Informal meeting on Code of Practice for Packing of Cargo Transport Units

Geneva and virtual, 12-13 July 2022

Load distribution

Submitted by IUMI and Mariterm AB

Figure 7.X An example of a load distribution diagram for the safe loading and handling of a 40-foot container, based on the following parameters:

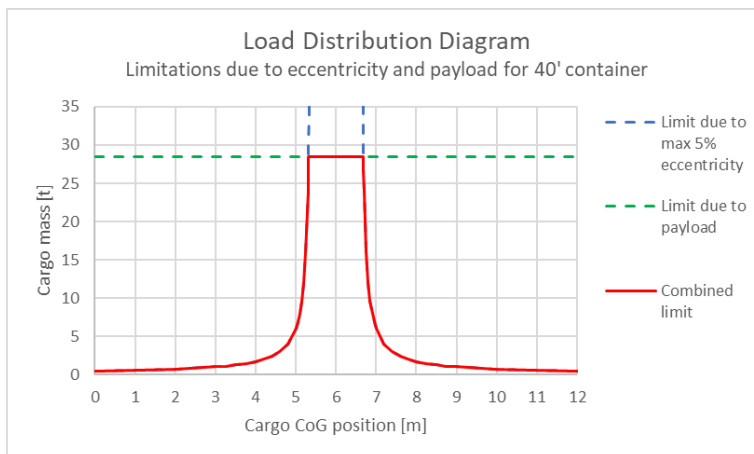
3.3.2 Where freight containers, including flatracks or platforms, will be lifted and handled in a level state during transport, the cargo should be so arranged and secured in the freight container that its joint centre of gravity is close to the mid-length and mid-width of the freight container. The eccentricity of the centre of gravity of the ~~cargo container's gross weight~~ **mass** should not exceed $\pm 5\%$ in general. As a rule of thumb this can be taken as 60% of the cargo's total mass in 50% of the freight container's length. ~~Under particular circumstances an eccentricity of up to $\pm 10\%$ could be accepted, as advanced spreaders for handling freight containers are capable of adjusting for such eccentricity. The precise longitudinal position of the centre of gravity of the cargo may be determined by calculation (see appendix 4 to this annex).~~

- Tare weight mass of container: 4000 kg
- Max Payload cargo weight (payload): 28 500 kg
- Maximum eccentricity: ±5% of the container’s length

Figure 7.22 An example of a load distribution diagram for a rigid truck

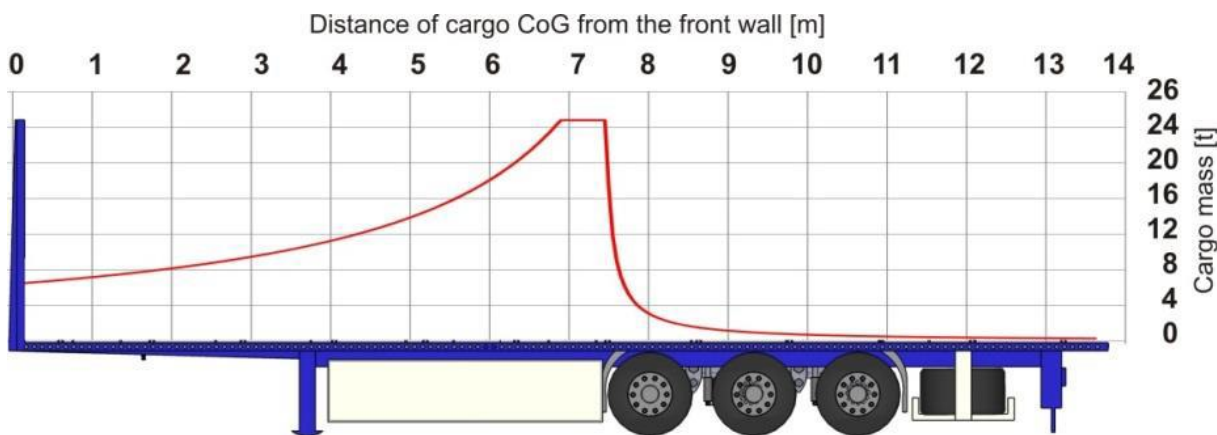
3.3.5 Road trucks and road trailers are in particular sensitive regarding the position of the centre of gravity of the cargo packed in them, due to the manufacturer’s specified axle loads for maintaining steering and braking ability as well as the infrastructure’s restrictions for vehicle gross weight mass as well as axle and bogie loads. In case of semi-trailers, the maximum king pin load, resulting from the towing trucks restrictions, must also be considered. Such Individual vehicles may be equipped with specific load distribution diagrams, which show the permissible cargo mass as a function of the longitudinal position of its centre of gravity. Generally, the maximum cargo mass payload may be used utilized only when the centre of gravity (CoG) is positioned within narrow boundaries about half the length of the loading space (see figures 7.22 and 7.23).

Remove example!

Figure 7.X An example of a load distribution diagram for a 40-foot container on a two-axle rail wagon, based on the following parameters:

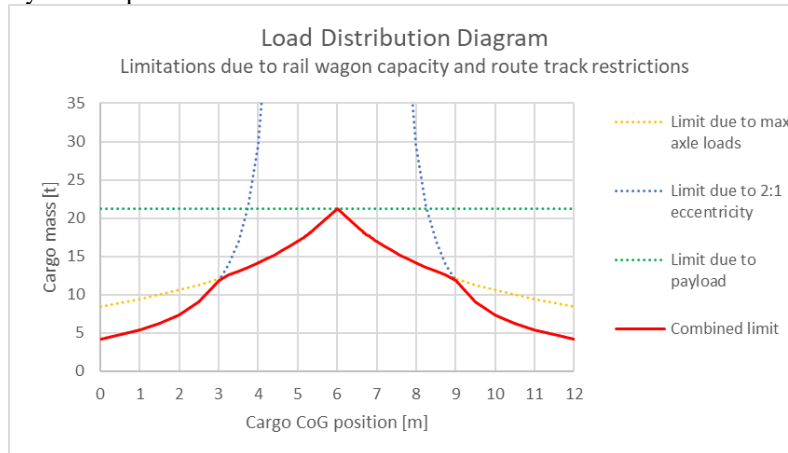
depending on their bedding length. The appropriate load figures are marked on the wagons. The transverse and longitudinal ~~deviation~~ **eccentricity** of cargo centre of gravity from wagon ~~centre-lines~~ **centrelines** is limited by defined relations of transverse wheel loads and longitudinal axle/bogie loads. The proper loading of railway wagons should be supervised by specifically trained persons.

- Maximum gross **weight mass** for wagon: 36 000 kg
- Tare **weight mass** of wagon: 10 800 kg
- Tare **weight mass** of container: 4000 kg
- Max cargo **weight mass** (payload): 21 200 kg
- Maximum axle load: 18 000 kg
- Distance between axles: 8 m
- Maximum difference between weight on axles: 2:1 (e.i. no axle may carry more than twice the weight of the other)

Figure 7.X An example of a combined load distribution diagram for the handling and capacity of a 40-foot container as well as transport on a two-axle rail wagon

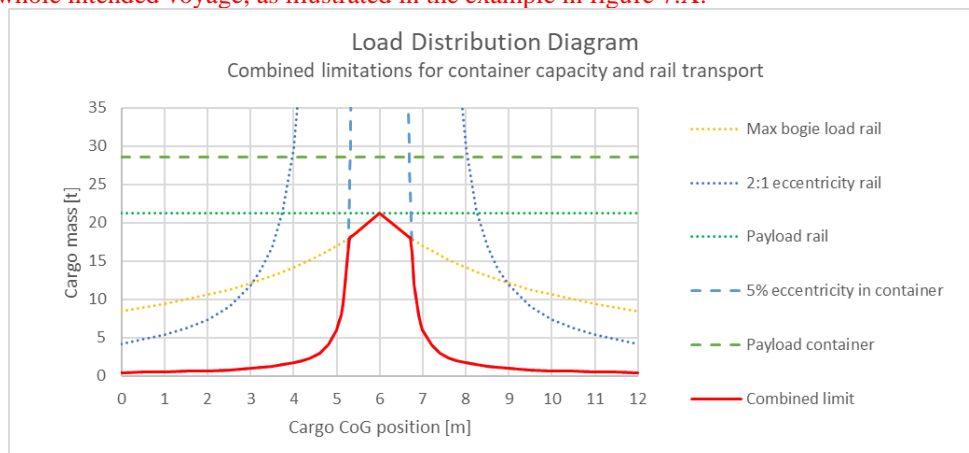
3.3.7 Load Distribution Diagrams for different modes of transport may be superimposed to show the combined limiting curve for the whole intended voyage, as illustrated in the example in figure 7.X.
